Access Compliance Report

Public Rights-of-Way

(Curb Ramps)

Intersection ID: N/A	Main Street: NATIONS_FORD_RD	Cross Street: N/A	Location: W
ADA ID: 44E0FD2BCD09	Ramp Type: Para	Initial Pass/Fail: Fail	Overall Compliance: No
Codes/Mitigation Info/Possible Solution		Field Measurements/Component Compliance

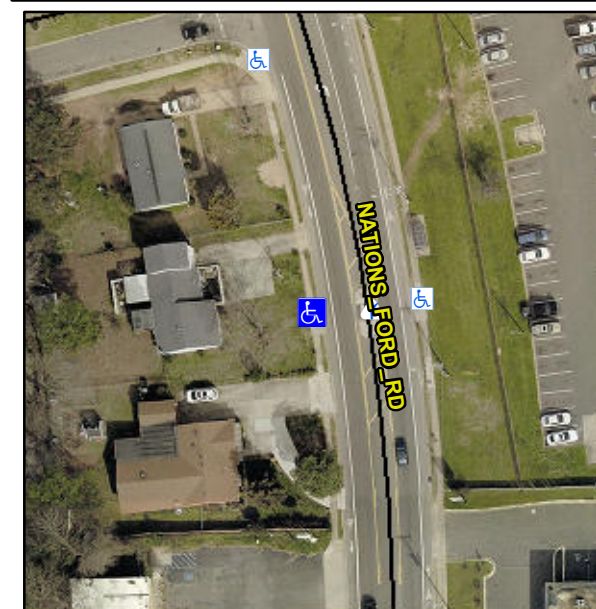
R304.3.2

Compliance	Description	Data	Compliance	Description	Data
N/A	Ramp Length LT (in)	73.0	N/A	Ramp Length RT (in)	73.0
Yes	Ramp Width LT (in)	64.0	Yes	Ramp Width RT (in)	64.0
Yes	Ramp Slope LT (%)	7.3	No	Ramp Slope RT (%)	8.8
Yes	Ramp XSlope LT (%)	0.9	Yes	Ramp XSlope RT (%)	0.9
N/A	Landing Length (in)	N/A	N/A	DWS Provided?	N/A
N/A	Landing Width (in)	N/A	N/A	DWS Contrast?	N/A
N/A	Landing Slope (%)	N/A	N/A	DWS Length (in)	N/A
N/A	Landing X Slope (%)	N/A	N/A	DWS Full Width?	N/A
N/A	Landing Curb? (Y/N)	N/A	N/A	DWS Offset (in)	N/A
N/A	Shared Landing?	N/A			
N/A	Gutter Ponding?	N/A	N/A	Gutter Slope (%)	N/A
N/A	Gutter Lip Ht (in)	N/A	N/A	Gutter X Slope (%)	N/A
N/A	Painted X Walk1?	No	N/A	Painted X Walk2?	N/A
	X Walk 1 Direction	To E		X Walk 2 Direction	N/A
N/A	X Walk 1 Width (in)	N/A	N/A	X Walk 2 Width (in)	N/A
	X Walk 1 Slope (%)	6.2		X Walk 2 Slope (%)	N/A
	X Walk 1 X Slope (%)	0.4		X Walk 2 X Slope (%)	N/A
N/A	Ramp inside XWalk1?	N/A	N/A	Ramp inside XWalk2?	N/A

Remove & Replace Entire Ramp.
